Extract of Previously Submitted Further Information

Table 1	Response-to-Comments
Appendix 1	Revised Planning Statement
Appendix 2	Revised Environmental Assessment
Appendix 3	Revised Drainage Impact Assessment
Appendix 4	Figure RC-01

Re: Section 16 Planning Application for Proposed Temporary Cold Storage for Poultry and Distribution Centre for a Period of 3 Years and Filling of Land for Site Formation Works at Lots 471 S.B RP (Part), 472, 473, 474, 475, 476, 483, 501, 502, 504 S.B, 505 and 506 S.B RP in D.D. 89 and Adjoining Government Land, Man Kam To Road, Sha Ling, New Territories

Section 16 Planning Application No. A/NE-FTA/220

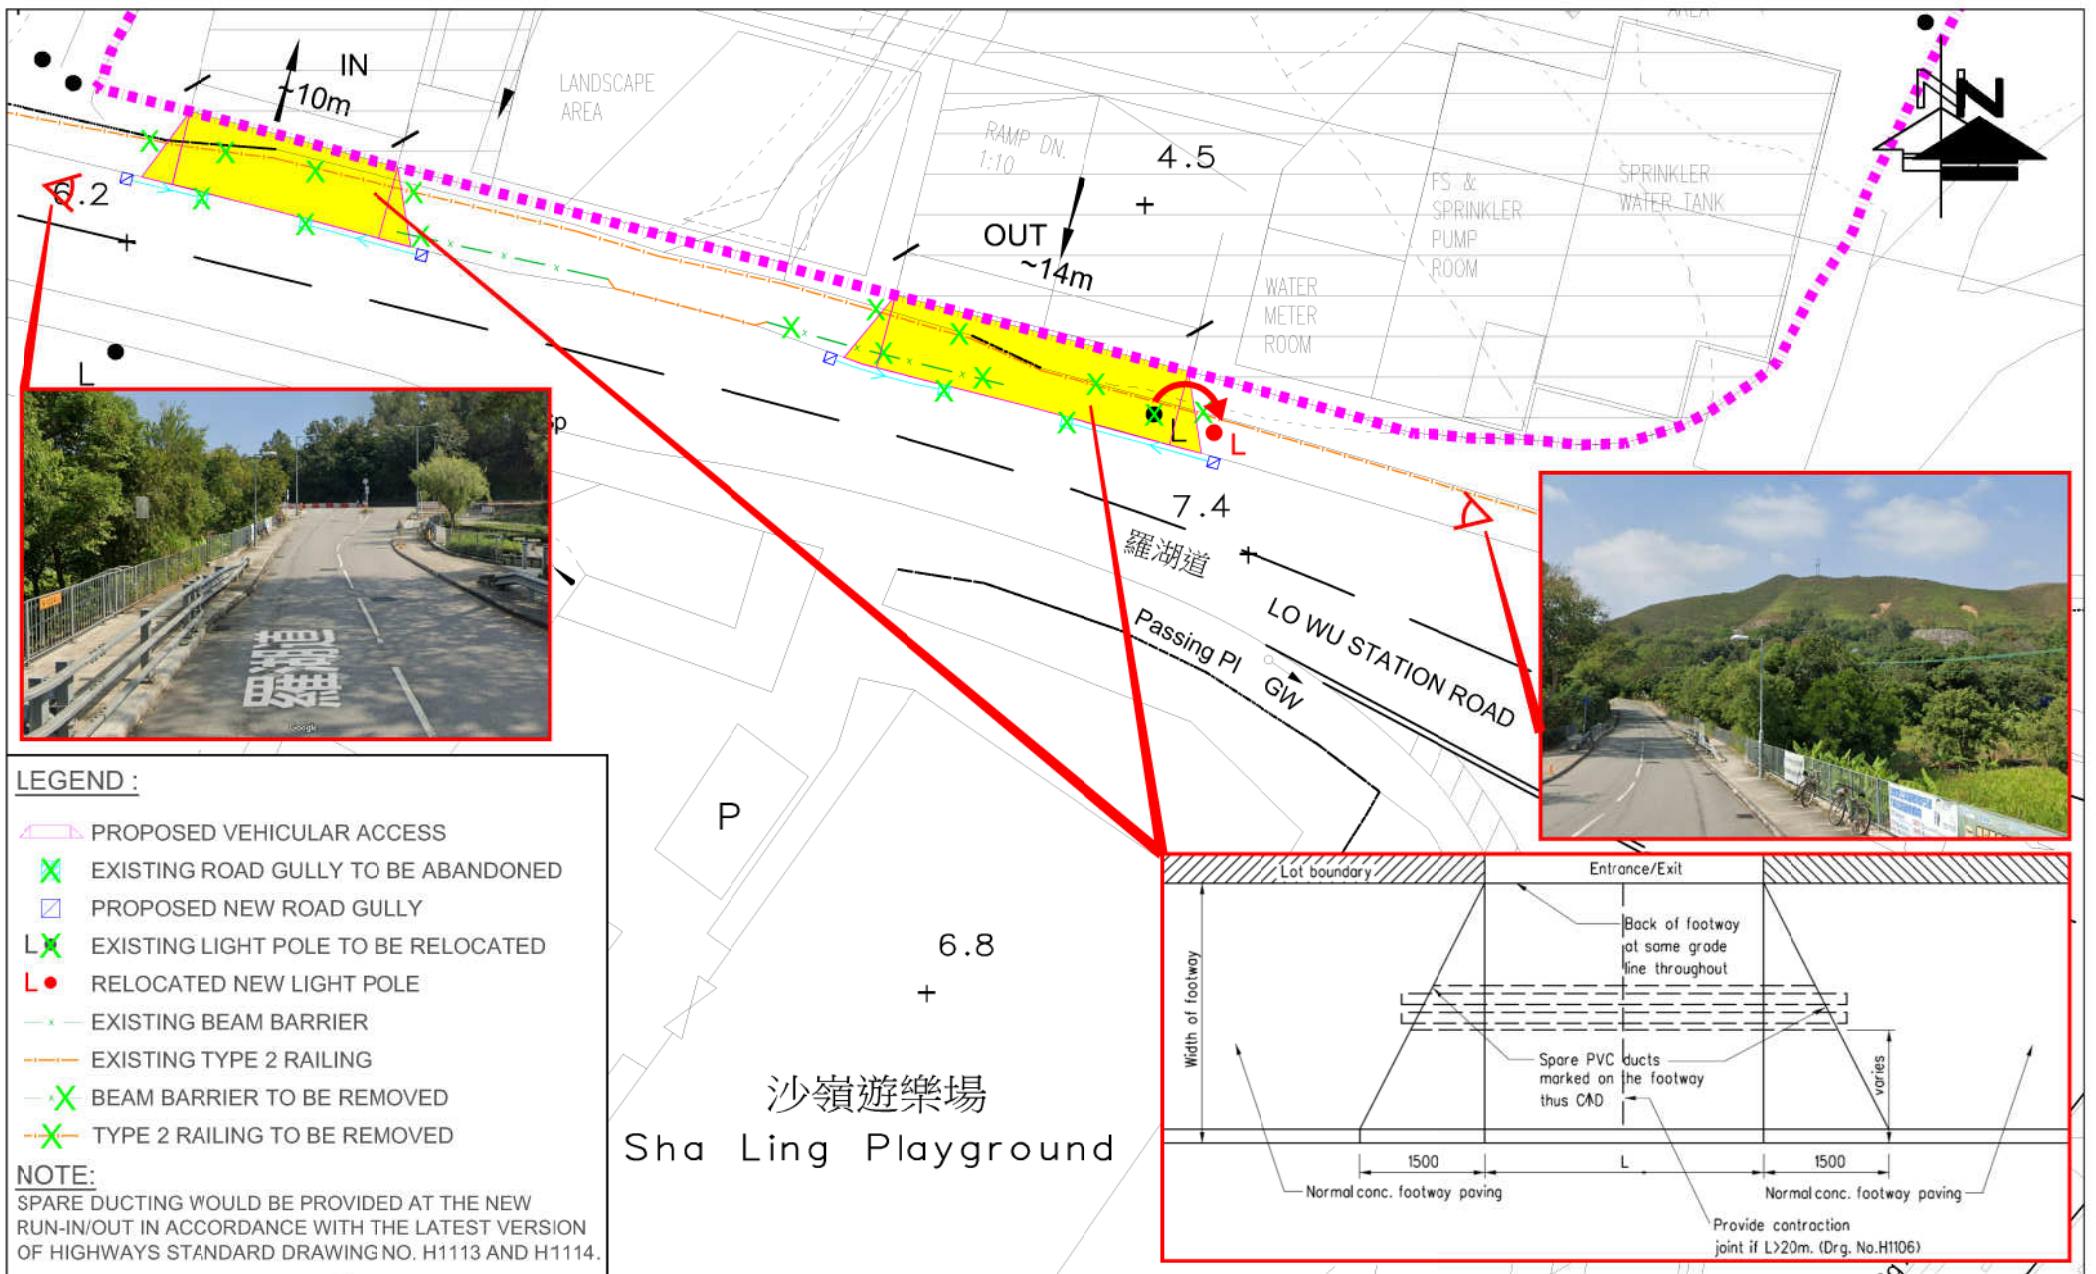
<p>2. Para. 4.6.1: As the existing railings and beam barriers will be</p>	<p>Noted. Please find the attached Figure RC-01 for your information</p>

Date	Bureau / Department	Comments	Responses
		<p>modified due to the proposed ingress/egress, please provide more details for review.</p>	<p>and detailed design will be further submitted for approval by relevant government departments once approval of this S16 planning application is sought (Appendix 4 refers).</p>
		<p>3. Para. 4.9.2: The u-channel proposed along the site boundary should be designed so that no surface run-off will flow from the site onto the adjacent public road.</p>	<p>Noted. The DIA concluded that the proposed and existing stormwater system will have sufficient capacity to receive stormwater runoff from the proposed use and its surroundings, and hence, no adverse drainage impact is anticipated.</p>
		<p>4. If the application is approved, the applicant is required to construct a proper ingress and egress for the site according to HyD’s Standard Drawings. Upon termination of the application, the applicant is required to reinstate the ingress and egress to their original state to my satisfaction at his own cost.</p>	<p>Noted.</p>

Title:
 Typical Section for Drainage Proposal

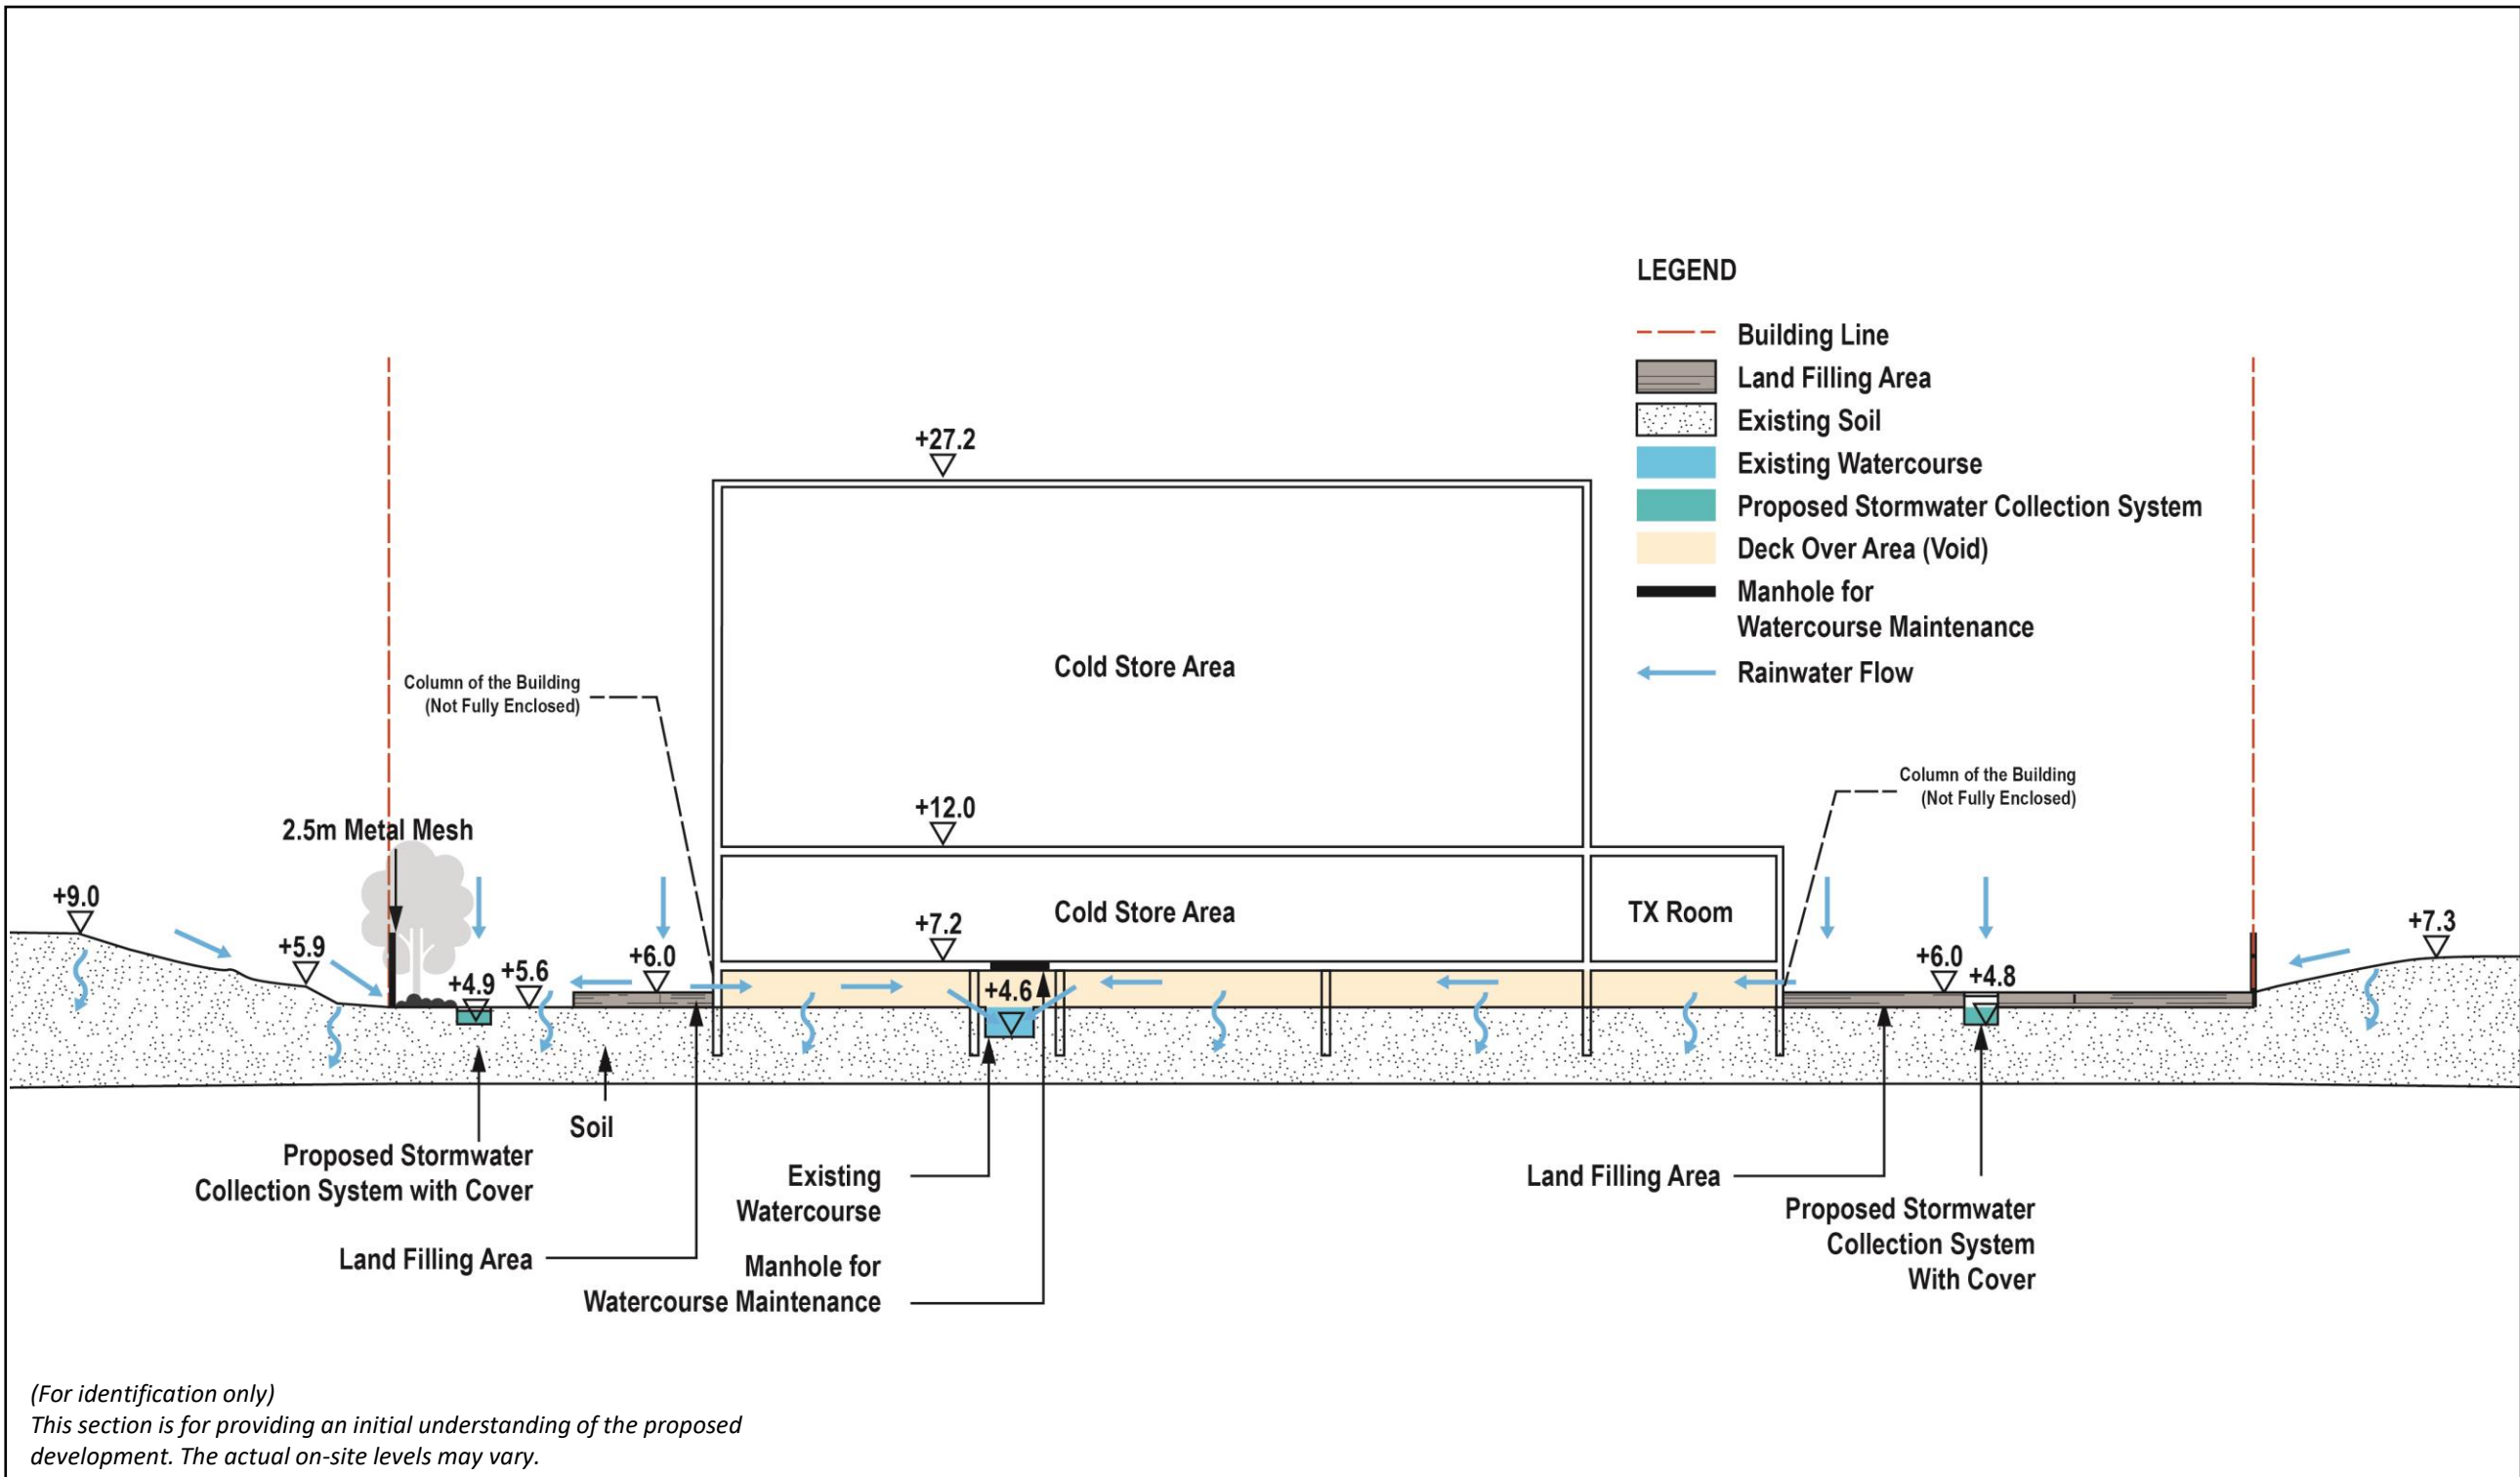
<p>4. RtC Item 7): Please provide section view at the site boundary to indicate the arrangement of peripheral U channel. Please also advise if hoarding/boundary wall is</p>	<p>Please note that the arrangement in a sectional view is in Appendix F. No hoarding will be provided, fence will be provided instead which</p>

Figure 1.1 Identification of Surrounding Catchment and surrounding environment

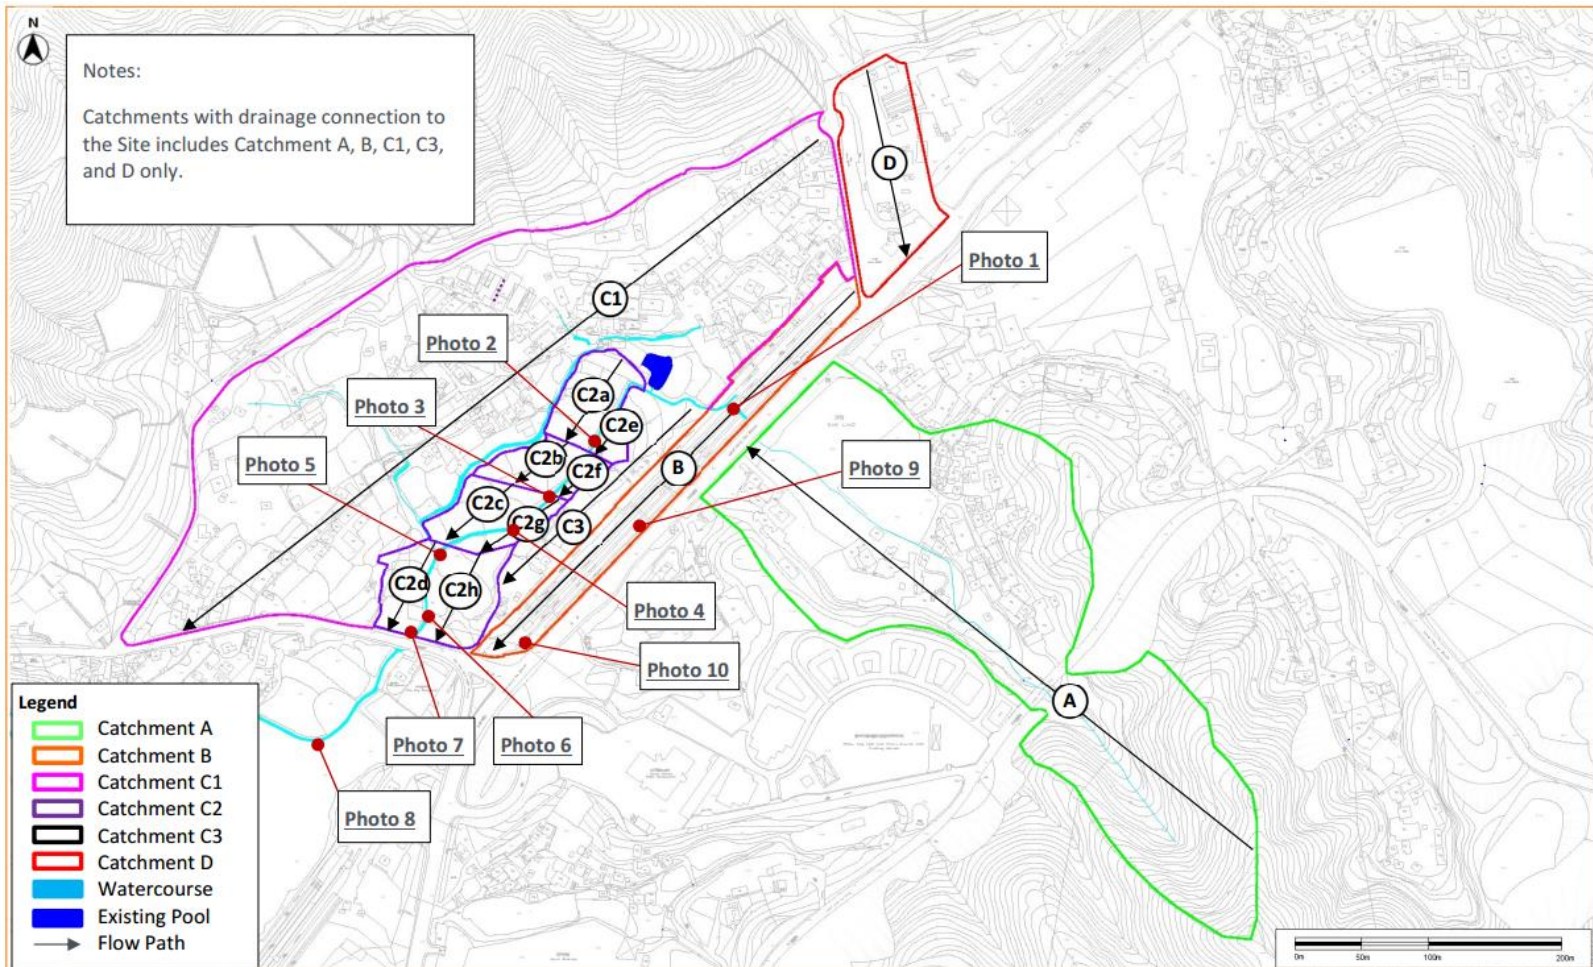
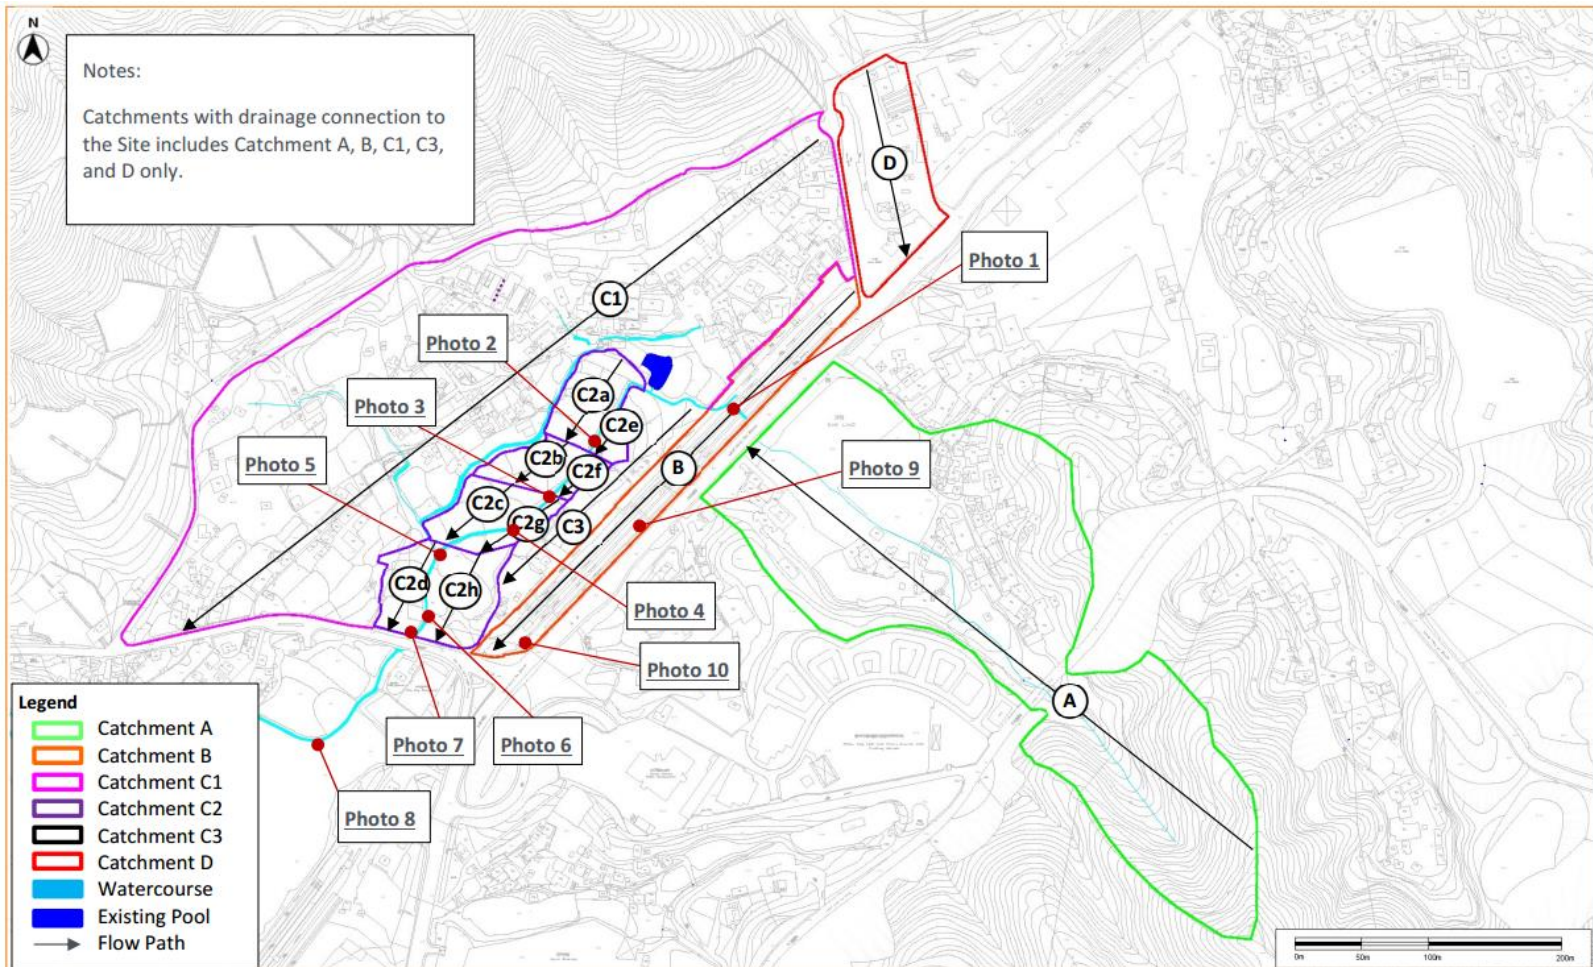
2. Please advise the actual condition of the existing stream. One of the assumptions is that the bedding material is taken as trapezoidal shotcreted channel. Please justify, with site photo if possible.	Site photos (Photo 1 to 7) taken in 2022 showing the actual conditions are attached in the hydraulic checking document for reference. The photos also show the trapezoidal channel appeared to be concrete-lined (see Appendix 3).
